Project Name:	Land at Bayards, Eastergate (Miller Homes)
Document Reference:	091.5016/SVR/5
Document Name:	SuDS Verification Report – Area 5
Prepared By:	Samuel Flesher
Checked By:	Meagan Weedon
Approved By:	Jon Soar

Revision Record				
Rev	Date	By	Summary of Changes	Aprvd
P01	08/05/2026	MDW	First issue.	JFS

Figure 3: SDS GEOLight Cross Section

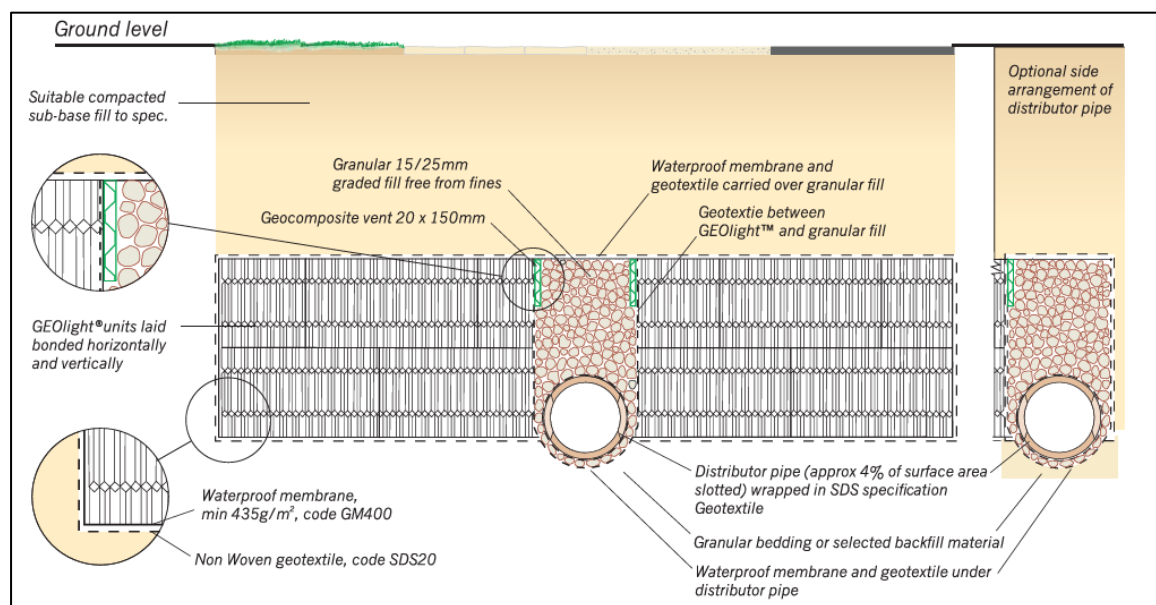
4.9 The SDS GEOLight system appears to have been substituted and installed in this area. This product typically requires a specific arrangement, including a perforated pipe running centrally through the attenuation crates, as illustrated in **Figure 3** below.

However, the contractor has instead installed an in-situ pipe that has been hand-cut with spiral slits to function as a perforated pipe, intended to feed water into the crates. This pipe appears to have been installed without appropriate bedding.

Furthermore, the structural integrity of the pipe has likely been compromised due to the hand-cut slits, which is also evident from the CCTV footage. There also appears to be no restraint preventing the pipe from shifting or rotating. As a result, there is no assurance that the slits will remain correctly oriented (i.e. facing downward towards the crates).

This may lead to ineffective interaction between the pipe and the attenuation system, potentially causing the drainage to perform in an unintended and unpredictable manner.

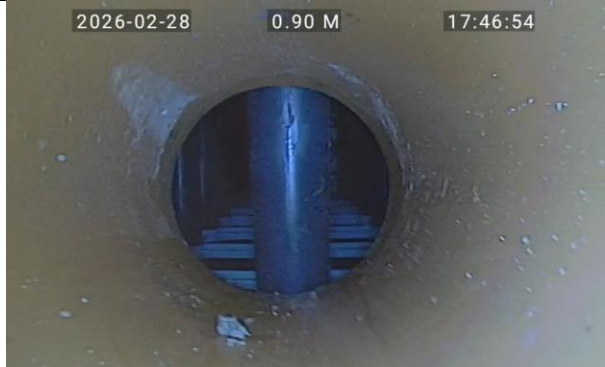
PSCP113-SA19		Sediment in manhole after catchpit, would suggest that either the catchpit isn't being maintained or has been constructed incorrectly. Preformed knockout panel has not been removed, this could restrict flow into the crate.
PS121-PSCP118		No visible major defects
PSCP118-SA20		Possible root ingress into attenuation crates
PS123-PSCP124		No visible major defects
PSCP124-SA21		No visible major defects
PS127-PSCP128		No visible major defects
PACP128-SA22		No visible major defects (footage only 4 seconds)

PS5291-SA23		Pipe appears to end with a bend that goes into the top of the crate, top appears to be the preformed knock out section. Suggesting crates have been laid incorrectly. Potential for structural stability to be undermined if this is the case.
PS140-PSCP141		No visible major defects
PSCP141-SA24-25		No visible major defects, however, this does not seem to reflect the photos provided of this soakaway. The CCTV indicates a side connection into the crate whilst the photos indicate the pipe is placed on top of the crate.
PS137-PSCP138		
PSCP138-SA24-25		Same pipe as PSCP141-SA24-25 was recorded in survey. Along with this, this does not seem to reflect the photos provided of this soakaway. The CCTV indicates a side connection into the crate whilst the photos indicate the pipe is placed on top of the crate.
